SERVICE BULLETIN

SB1261

ADDRESSEES	: Owners and users of vehicles mentioned under "Application"
VEHICLE TYPE	: T2100, C2045, CX, TX, TD925US, TDX25US, A300K, A300L, A330, AG300
CONFIGURATION GROUP	: 7.06 Steering – front-axle steering
BULLETIN TYPE	: Service Information
DATE	: May 08 th , 2015
SUBJECT	: Bevel gear of front axle steering system
TERMS & CONDITIONS	: Refer to the warranty section further in this Bulletin.

IDENTIFICATION

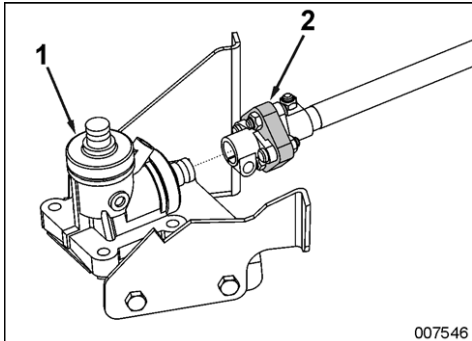
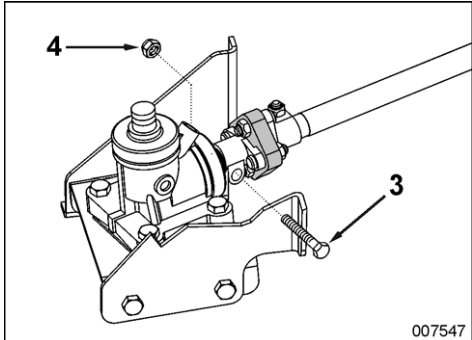
Old and new bevel gears are interchangeable, but note that two different types of bevel gears are used (refer to "Versions" further on in this Bulletin for application). Also note that the new bevel gear has a mid-position which should be taken into account during the installation of the bevel gear.

Original Pailton bevel gear	Upgraded Pailton bevel gear (additional dust cover at input and output shafts)	New ZF bevel gear
With long input shaft			
With short input shaft

3. Procedure to check bevel gear rotating torque

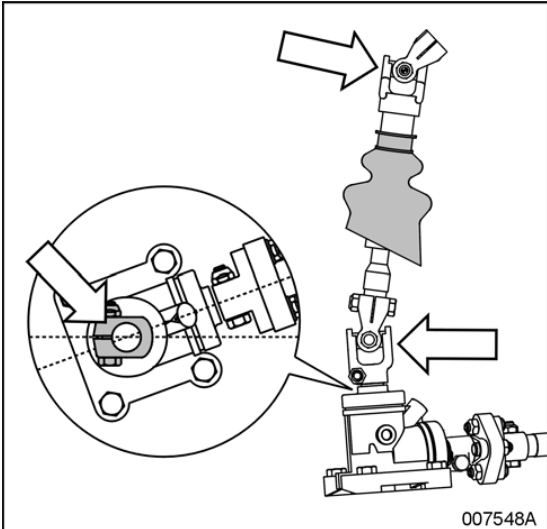
Step	Action
1	Position the bevel gear on a work bench.
2	<p>Position a torque tester suitable for measuring small torques at the input or output shaft of the bevel gear. Check the bevel gear rotating torque by progressively increasing the force on the arm of the tester. The bevel gear must be replaced when the reading on the torque meter exceeds 0,7 Nm (0.52 ft.lbf).</p>
